<b>DEVELOPMENT NO.:</b>	21026188
<b>APPLICANT:</b>	Gregory Phillips
<b>ADDRESS:</b>	239A Esplanade, Seacliff SA 5049
<b>NATURE OF DEVELOPMENT:</b>	Detached dwelling with wall located on southern side boundary comprising a total of 4 levels and an underground cellar
<b>ZONING INFORMATION:</b>	<p><b>Zones:</b></p> <ul style="list-style-type: none"> <li>• Waterfront Neighbourhood</li> </ul> <p><b>Overlays:</b></p> <ul style="list-style-type: none"> <li>• Airport Building Heights (Regulated)</li> <li>• Affordable Housing</li> <li>• Prescribed Wells Area</li> <li>• Regulated and Significant Tree</li> <li>• Stormwater Management</li> <li>• Urban Tree Canopy</li> </ul> <p><b>Technical Numeric Variations (TNVs):</b></p> <ul style="list-style-type: none"> <li>• Maximum Building Height (Metres)</li> <li>• Minimum Frontage</li> <li>• Minimum Site Area</li> <li>• Maximum Building Height (Levels)</li> </ul>

<b>LODGEMENT DATE:</b>	2 Sep 2021
<b>RELEVANT AUTHORITY:</b>	Assessment Panel at City of Holdfast Bay
<b>PLANNING &amp; DESIGN CODE VERSION:</b>	26 August 2022 2021.12
<b>CATEGORY OF DEVELOPMENT:</b>	Code Assessed - Performance Assessed
<b>NOTIFICATION:</b>	Yes
<b>RECOMMENDING OFFICER:</b>

**Red outline highlights development on the northern boundary**

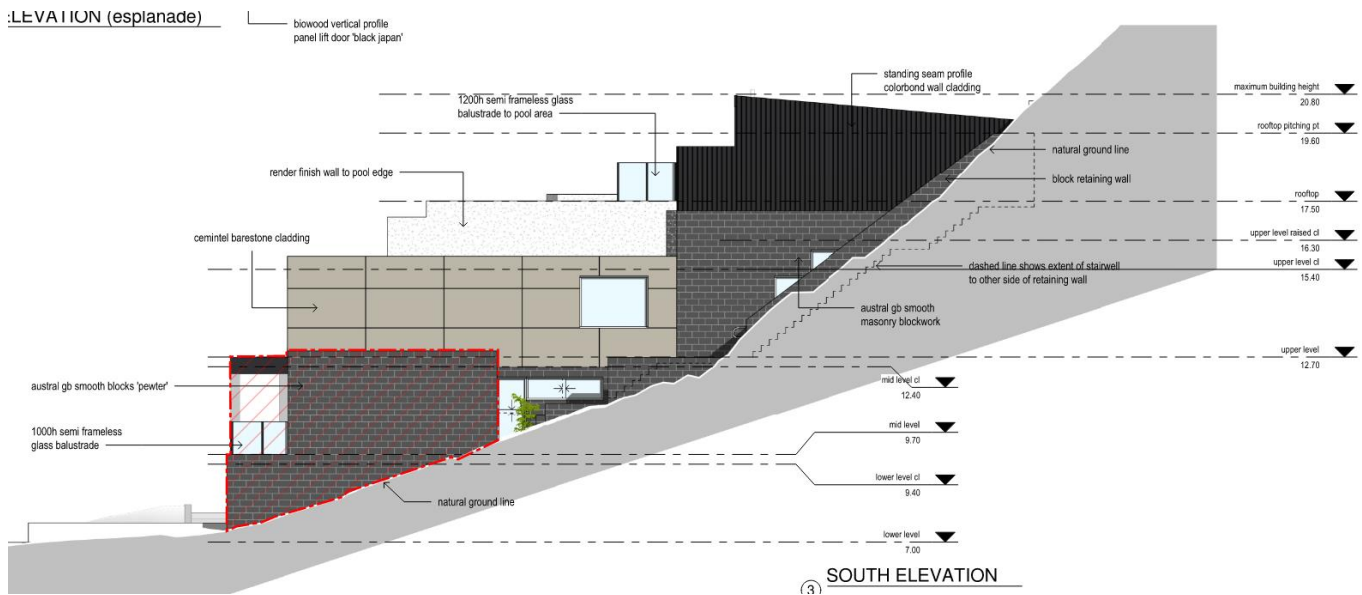
The northern elevation has a partial wall up to 7.2 metres in height, which will be to the west of the neighbouring buildings south facing windows, therefore it will not be directly in view (the upstairs window is obscured, and the ground level window is behind an existing fence, hence, the view from the windows will not be direct. The proposed building is setback some 1.5 metres from the boundary where those south facing windows are positioned, therefore the visual impact will not be significant. Due to the orientation, overshadowing will not occur.

**Red outline highlights development on the southern boundary**

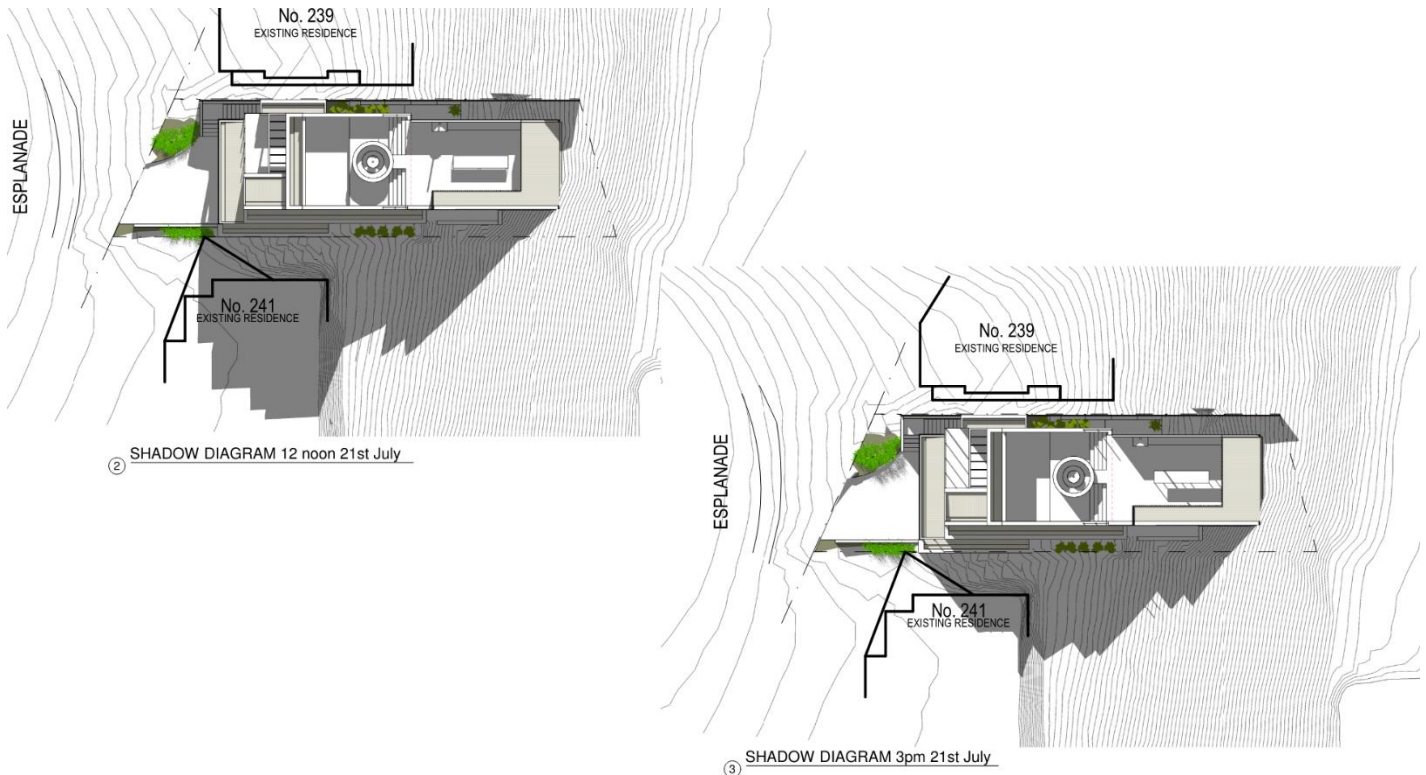
The southern elevation has a solid boundary wall up to 6.8 metres in height, which will abut a carport and balcony on the southern adjacent property. The wall will in effect, create a solid wall on the northern side of the adjacent carport and balcony. This will result in result in both a visual and overshadowing impact to the southern adjacent property.

***Shadow overlay demonstrates shadow cast over southern adjacent building and part of rear yard at midday, and shadow cast at 3pm, which is predominately away from the southern adjacent building.***

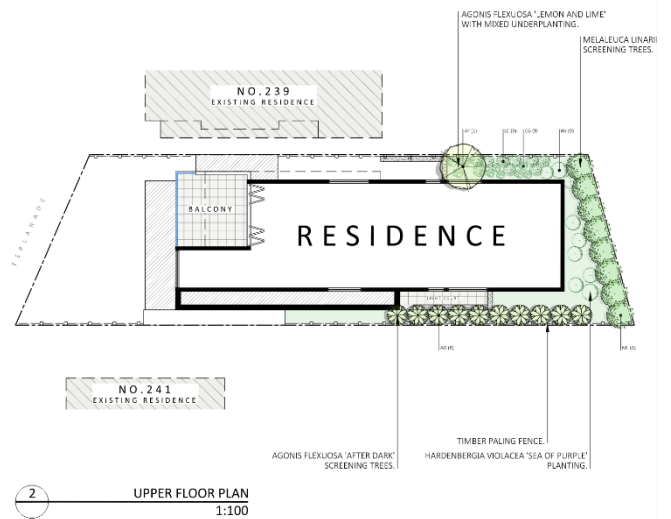
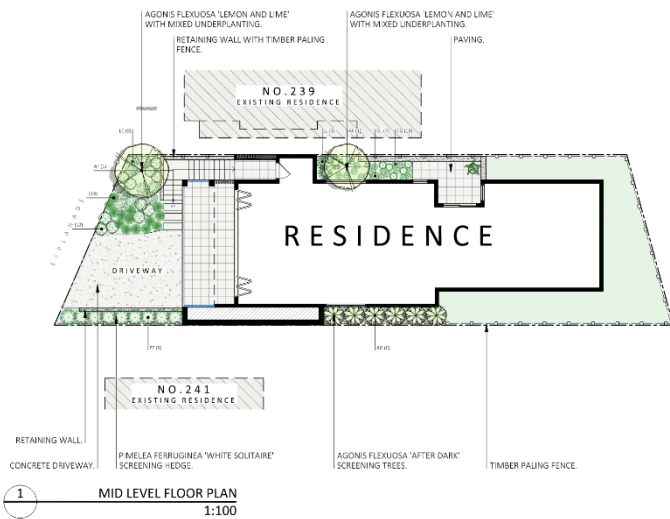
When assessing the proposal against the above Performance Outcomes with respect to overshadowing, when considering the shadow diagrams submitted, it is noted that, during the Winter Solstice, in the morning, all properties are naturally overshadowed due to the topography of the land.

At midday, the proposed building would cast a shadow directly over the southern adjacent property, including its north facing windows and part of the rear yard

At 3pm, the shadow would be cast over a small portion of the north-east rear corner of the building and part of the rear yard.

On balance, the proposal is able to ensure sunlight and ventilation to the southern adjacent property.

PLANT PALETTE

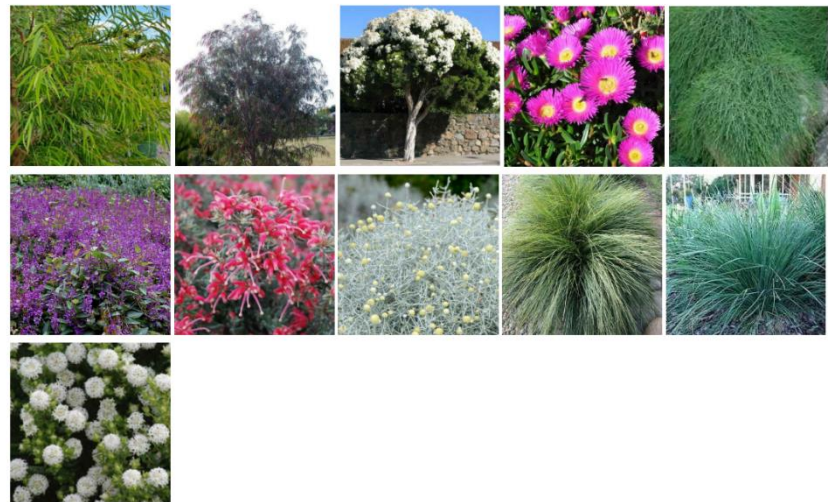
The Design Code requires a minimum of 20 percent of the site area dedicated as soft landscaping. The site has an area of 334 square metres, therefore a minimum of 66 square metres should be landscaped. The proposal demonstrates a total landscaped area of 88 square metres, which equates to 26 percent of the site area. 31 percent of the total landscaping is in the front yard.

The Design Code requires the planting of at least 1 small tree (grown height 4 metres and spread of 2 metres). The proposal comprises the planting of 3 *Willow peppermint* trees (growth height 8m), 14 *After dark peppermint willows* (growth height 3-6m) and 6 *Paperbark* trees (growth height 2.5m), therefore demonstrating a high level of quality landscaping. The remaining landscaping comprises a variety of ground covers and shrubs.
